## Author's Response to Referee #2

We would like to thank the anonymous Referee #2 for the detailed review and for the time spent reviewing our text. We replied to the referee's comments, which are incredibly useful to improve the quality of our manuscript. Note that the original referee's comments are identified as **R2C** and written in **bold**, and the authors' responses are labeled as **AR**. In addition, all comments are numbered (*e.g.*, **R2C-01**).

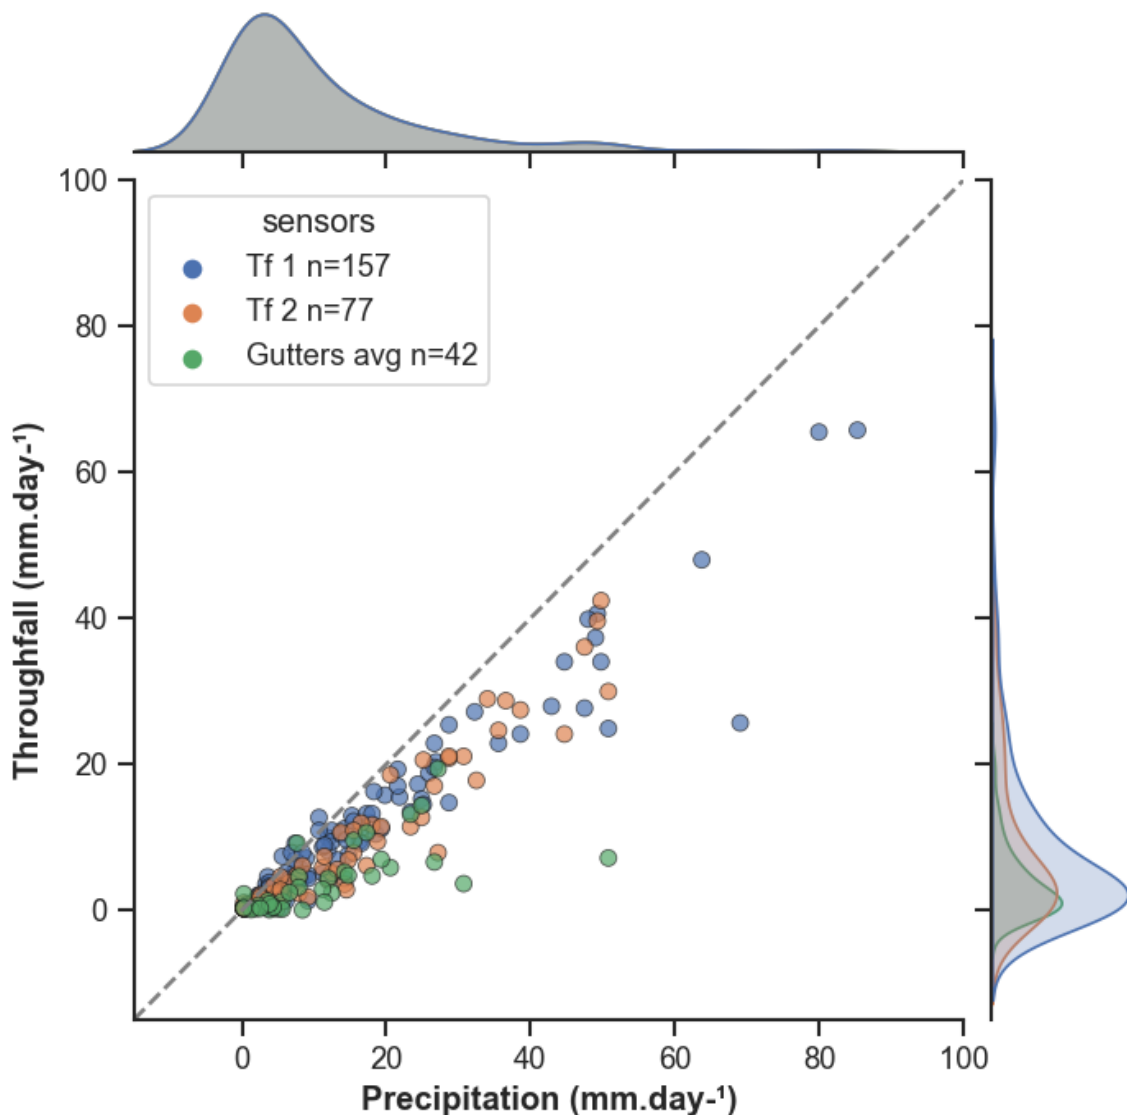
**R1C-03:** Because the canopy in this site is discontinuous (line 93), I could expect that the spatial heterogeneity of throughfall would be very high. Please show the differences in throughfall amount measured by four Davis, five manual gutters and three automatic

**gutters. The differences are related to the canopy openness? Also, a total of 12 measurements of throughfall are safely enough to obtain spatial representative value?**

AR: We intended to use all automatic throughfall measurements to have a representative average throughfall. However, the gutters (manual and automatic) had a bunch of clogging problems, and as we mentioned on R1C-02 because of its size of the gutters, only records during storm with intensity greater than 3 mm were considered to the average throughfall estimates.

The analysis of the pluviographs showed high values to the coefficient of quartile variation (CQV), between 79% and 90%, and high value of the coefficient variation for daily values ( $>170$ ), which confirm the heterogeneity of the spatial distribution. The spatial heterogeneity of precipitation was also confirmed by the observed throughfall records ( $< 1.27 \text{ mm}\cdot\text{day}^{-1}$  on days with no rain (24 days of observations)). The effect of the heterogenous vegetation and canopy structure on throughfall distribution in the study was also observed through the 10 days which in the average throughfall was greater than the precipitation (average greater just  $0.58 \text{ mm}\cdot\text{day}^{-1}$  and maximum difference of  $3.04 \text{ mm}\cdot\text{day}^{-1}$ ). Despite the effects of the heterogenous spatial distribution of rainfall and heterogeneous vegetation the pluviographs and gutter presented good correlation with the daily precipitation,  $>0.94$  and  $>0.87$ , respectively. The following figure show the daily values of the three pluviographs with more data in relation to daily precipitation.

Figure 1. Relation between daily infiltration and precipitation.

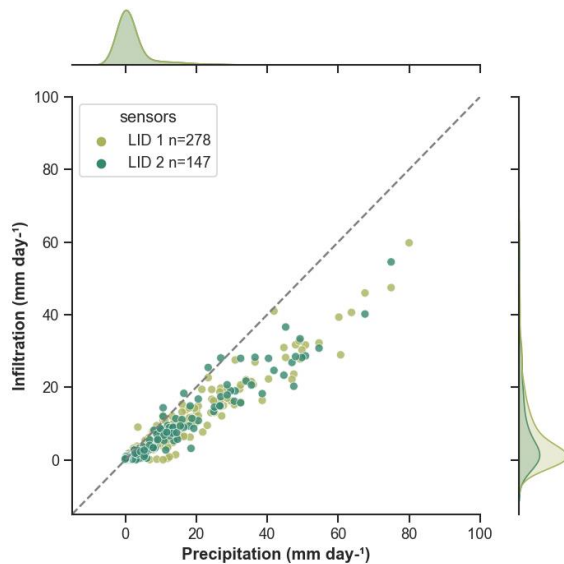
**R1C-08: Forest floor interception was measured by two LIDs (line 121-122). Please show the evidence indicating two LIDs could safely measure the spatial representative value of forest floor interception. This is very critical, because high spatial heterogeneity of throughfall could be expected from the disconnected canopy in this site.**

AR: It is undoubtable that more LIDs would better represent the forest floor interception of the study area. However, due to the cost of sensors and dataloggers, our data were based only these two LIDs.

Despite the few numbers of LIDs, the infiltration records monitored by these LIDs had good correlation among them (spearman coefficient equal 0.91, without zeros in the series), and the daily infiltration from both equipment have similar dispersion (Figure 1). The daily evaporation and storage of the forest litter measured by the LIDs presented good correlation, 0.73 and 0.77, respectively. The LID 2 usually stored and evaporated more than LID 1 (Figure 2), and that was due to the differences of the litter samples (weight and height), among other factors.
